Northern Link Environmental Impact Statement Supplementary Report

APPENDIX B RESPONSE TO SUBMISSIONS

■ June 2009

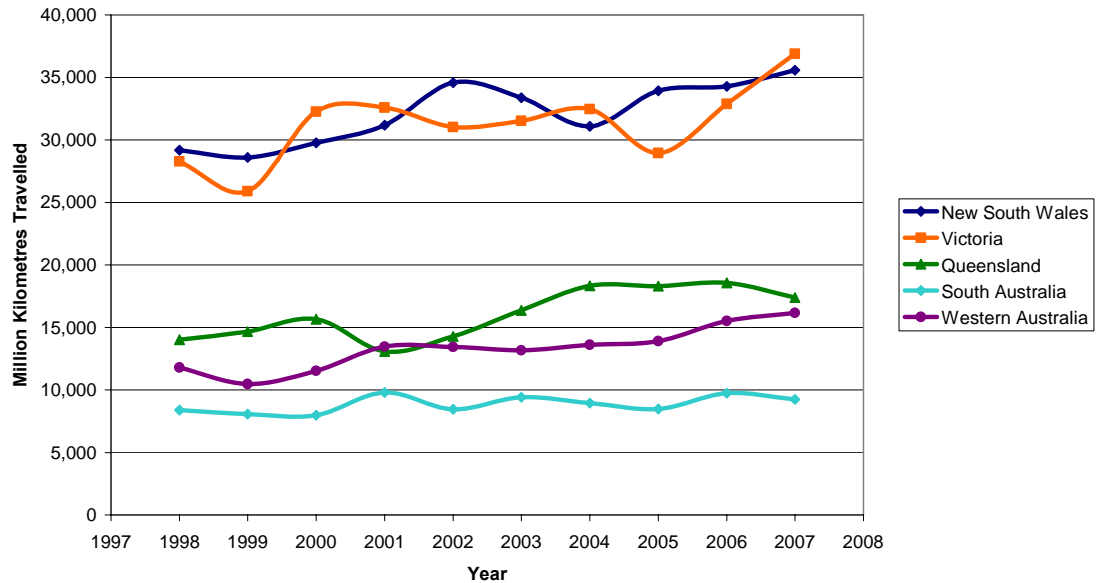
A submission has identified that the EIS assumes that dependence on private vehicle travel will continue to predominate and that distance travelled by private vehicle will continue to increase. However, latest statistics for Queensland indicate that total kilometres travelled private passenger vehicles have been reducing since 2005 (especially in Brisbane City). The implications of this phenomenon should be investigated, especially in testing the sensitivity of the cost-benefit assessment and business case models

The reported reduction in Brisbane VKT presented in the 2008 edition of Queensland Travel Facts⁸ (QTF) does not appear to indicate a trend which would affect the Northern Link traffic modelling, for the following reasons:

- Both QTF and its key source, the ABS “Survey of Motor Vehicle Use”, explicitly warn of the dangers of year-to-year comparisons. Such comparisons are subject to high relative errors due to the survey methodology, as well, in the case of the QTF, as methodology changes over time.
- Examination of capital city VKT figures over time, from the ABS data, shows that the apparent recent decrease in VKT in Brisbane is not unusual compared to other apparent changes in other years in other states. As **Figure 3** shows, the data indicates apparent growth in other capital cities in the last few years.
- Historical traffic volumes on Northern Link’s key connecting routes do not show a reduction in usage in these years, but rather indicate continuing growth, as illustrated in **Figure 4**.

Table B-39 summarises modelling predictions with regards the key indicators of nitrogen dioxide (NO₂) and particulates (PM₁₀). Other findings are presented in **Figure B-5** to **Figure B-11**.

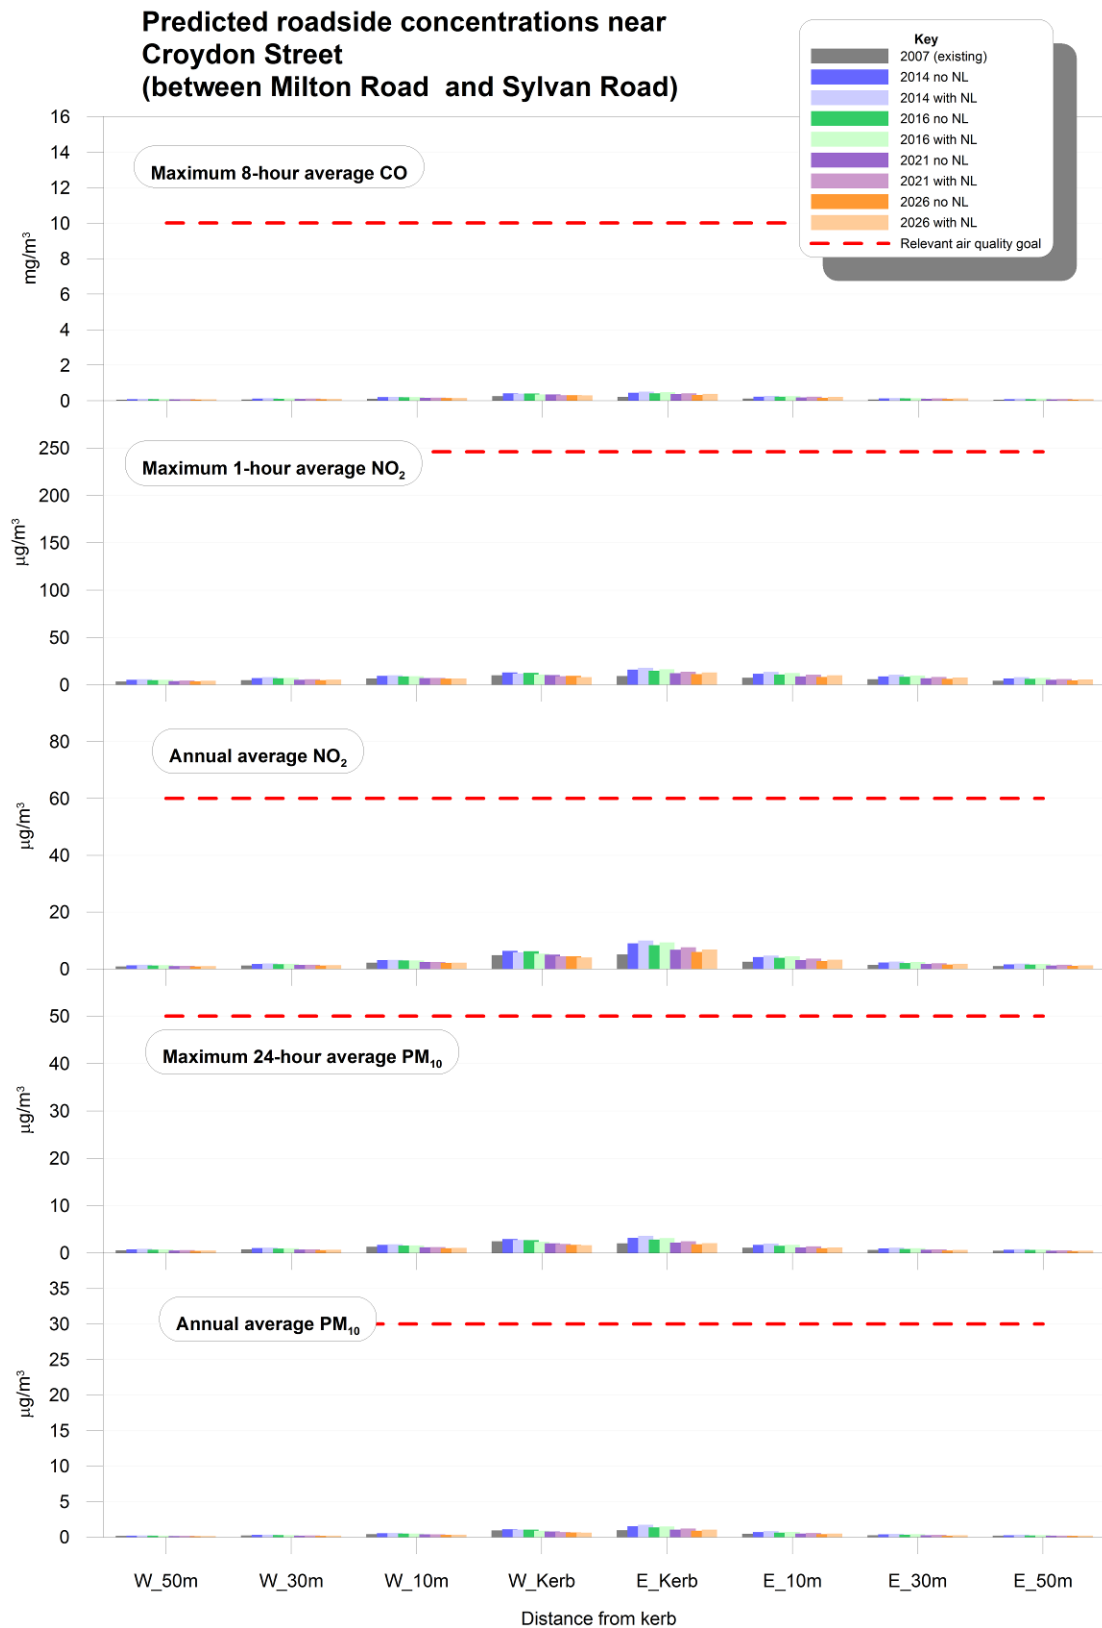
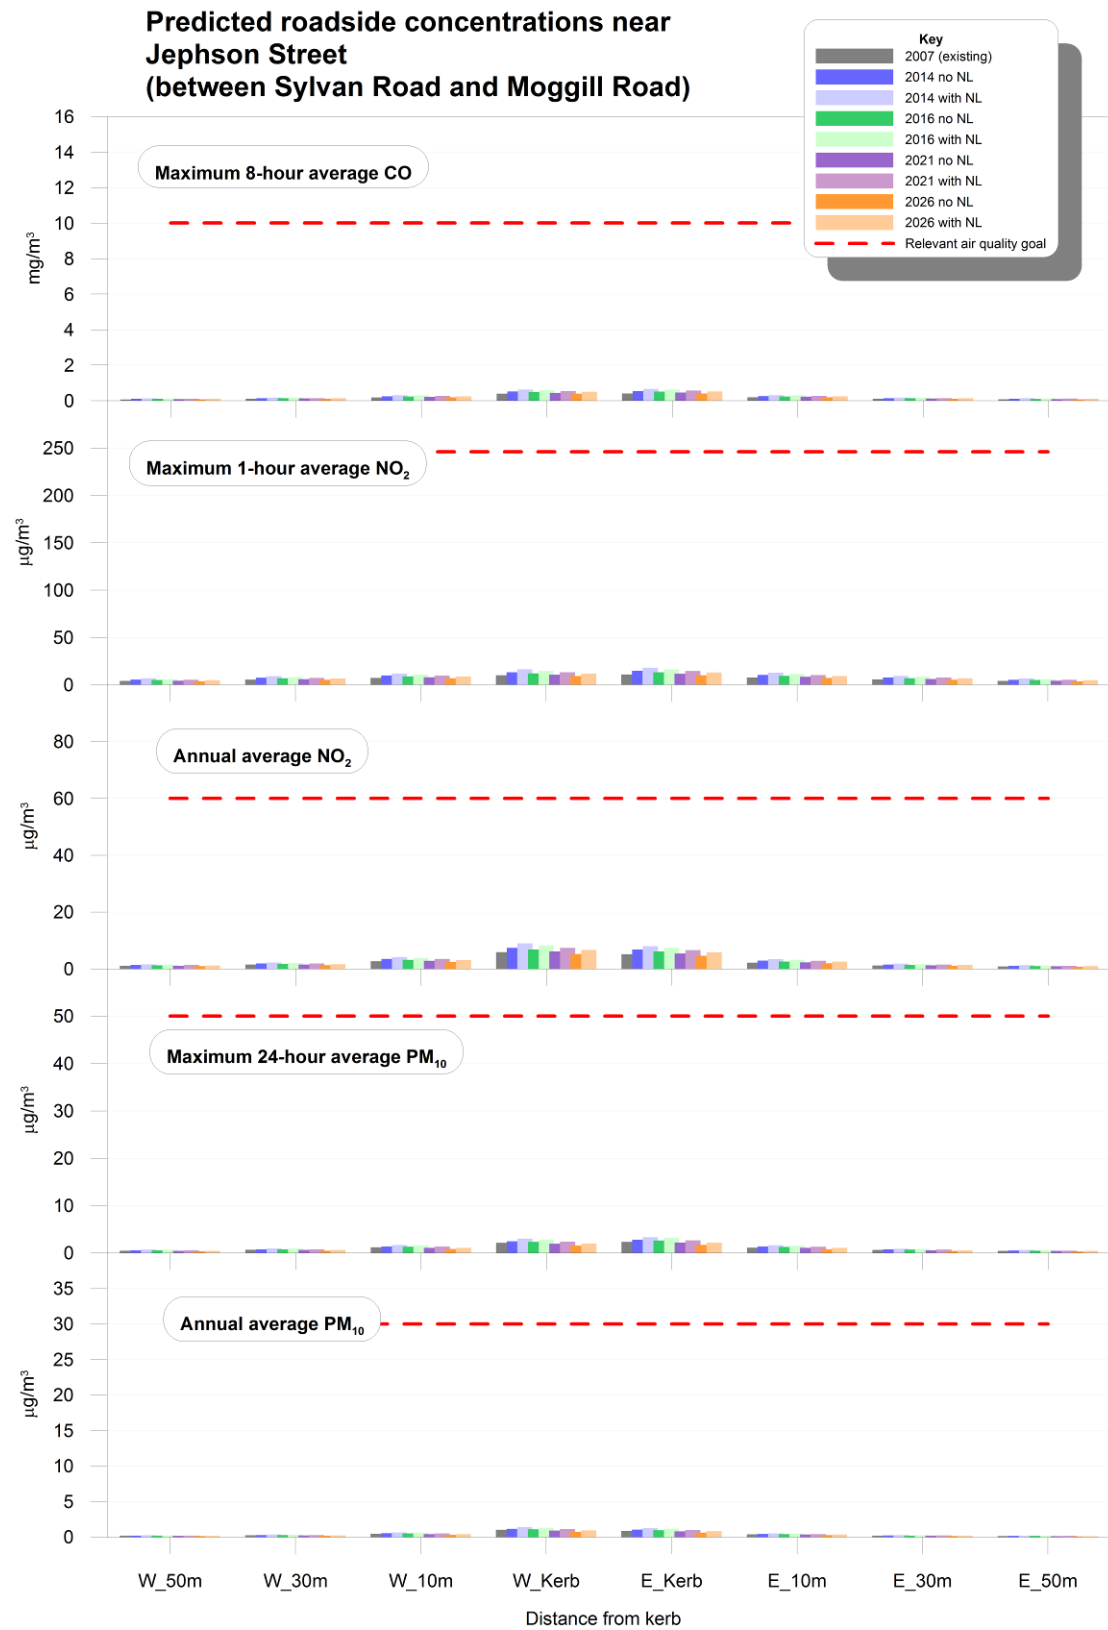
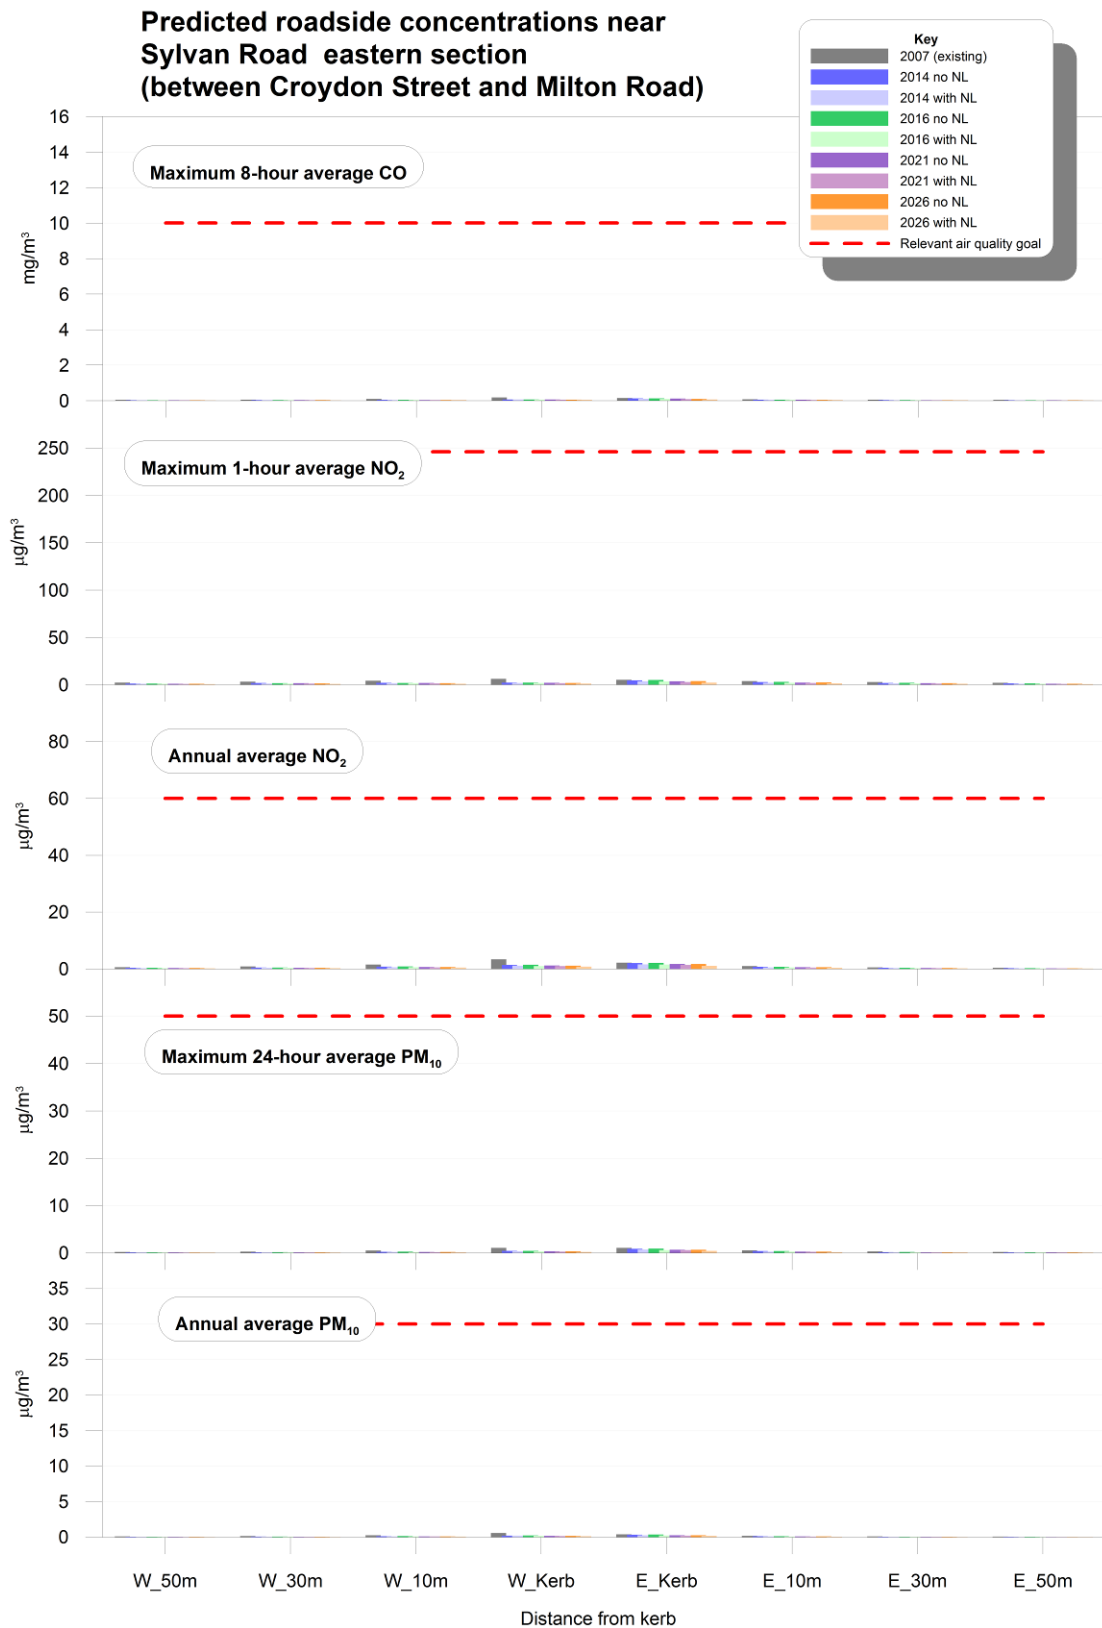
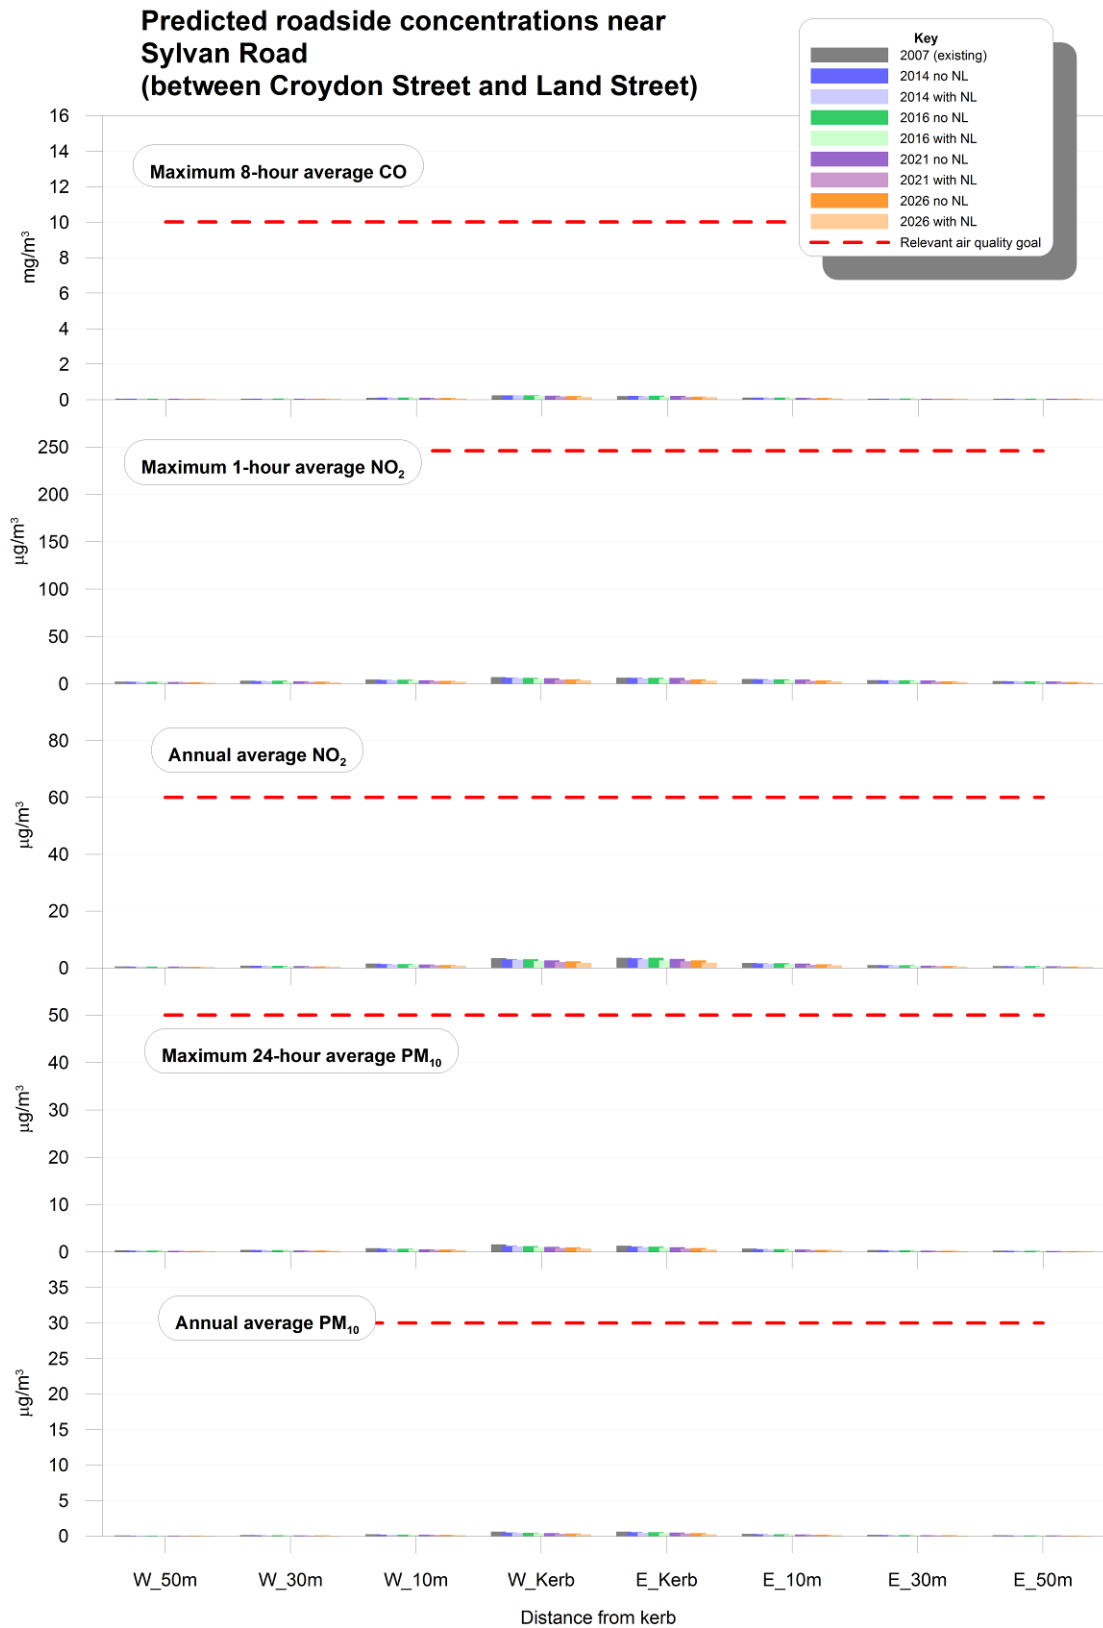
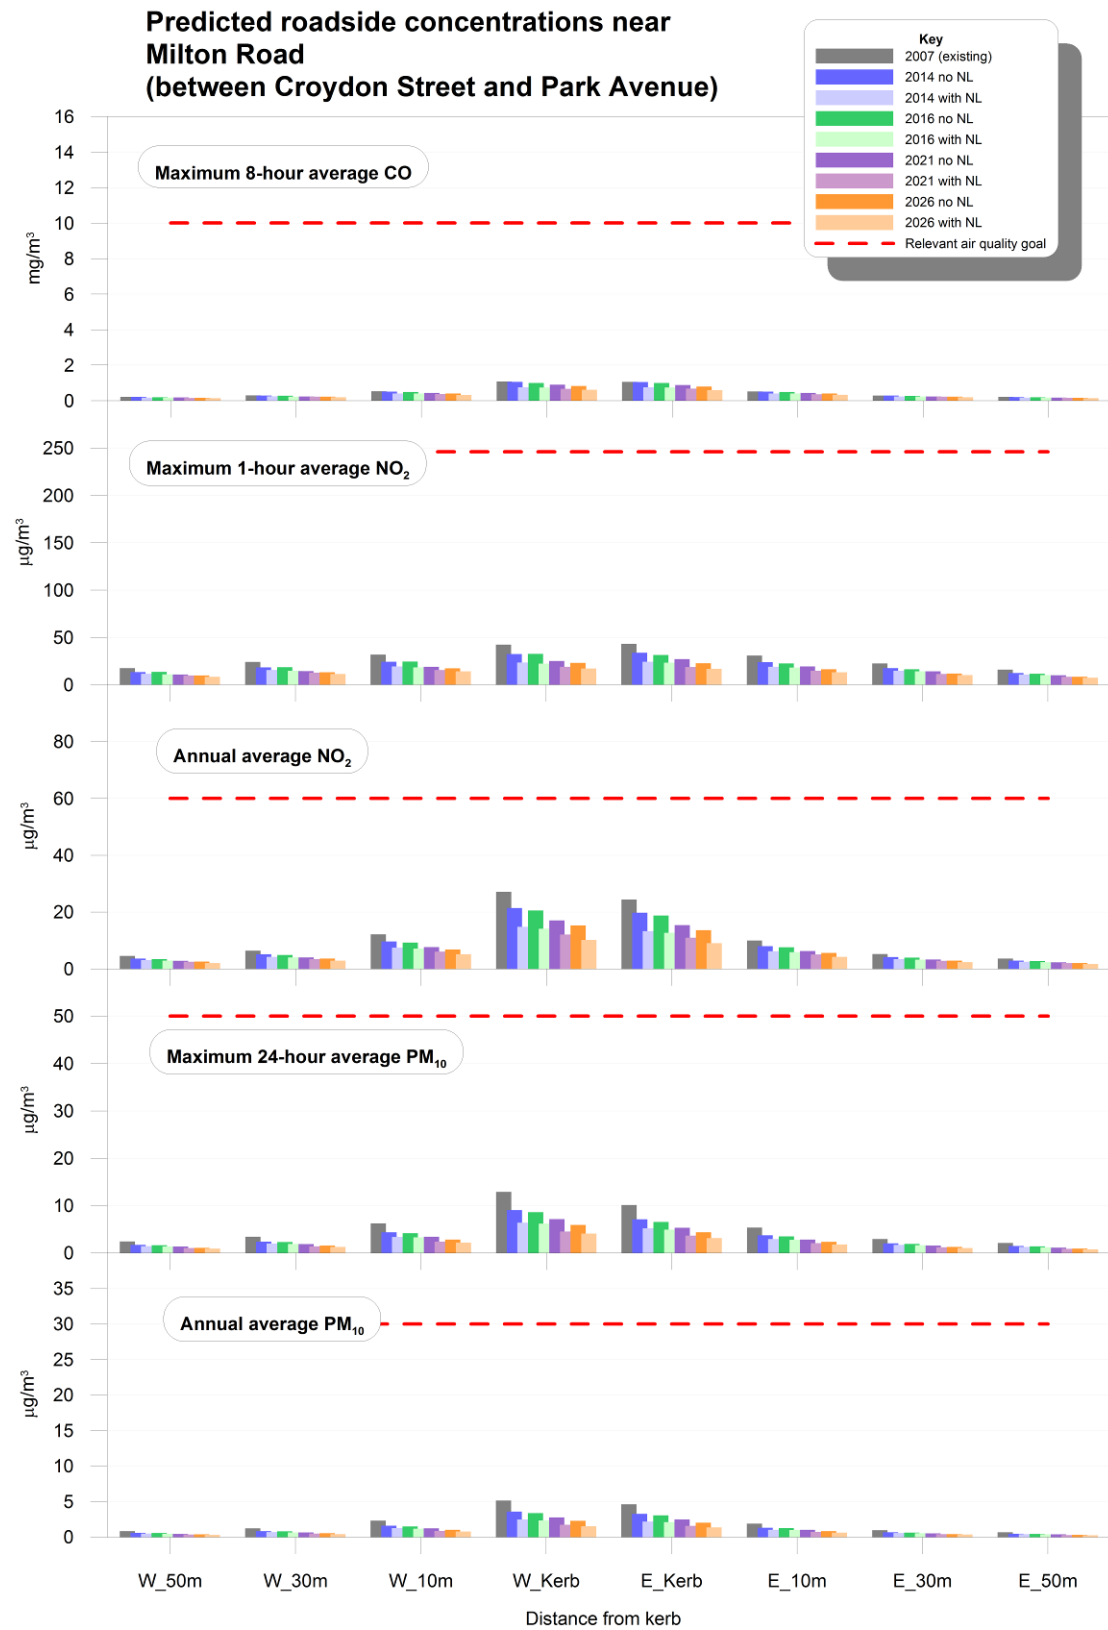
Some submissions raised concerns that ambient air quality in the vicinity of the Toowong State School would be diminished as a consequence of Northern Link. The modelling for Sylvan Road, between Croydon Street and Milton Road, provides relevant predictions of ambient air quality adjacent to the school. The predicted changes indicate minimal to negligible decreases in the concentrations of both nitrogen dioxide and particles (PM₁₀) in response to a forecast minimal reduction in traffic flows on this section of Sylvan Road.

Council has decided to remove the local connections with the effect that there will be minimal to negligible change in detectable ambient air quality associated with forecast changes to local traffic within the areas noted in the submissions.
